E220 Z Splice Plate will replace the E218 Splice Plate effective by December 1, 2007.

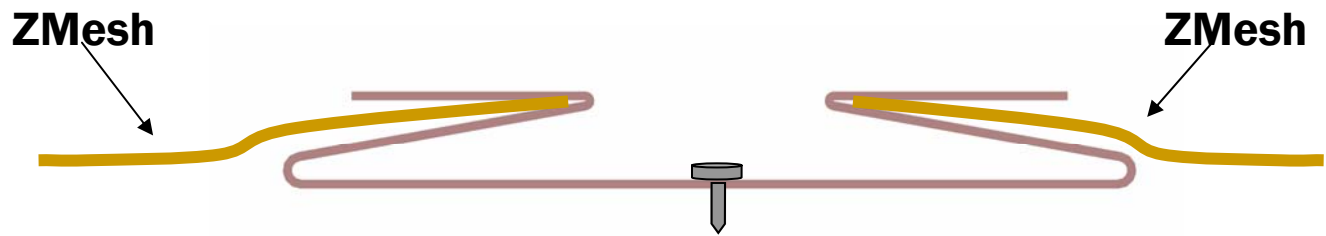
The plate has a "Z" fold on both sides for simplified splicing of ZMesh heating element. The ZMesh slides into each Z fold, is gently crimped or compressed, and then soldered as usual. Always keep the flame of the soldering torch on the "Z" fold and never on the ZMesh.
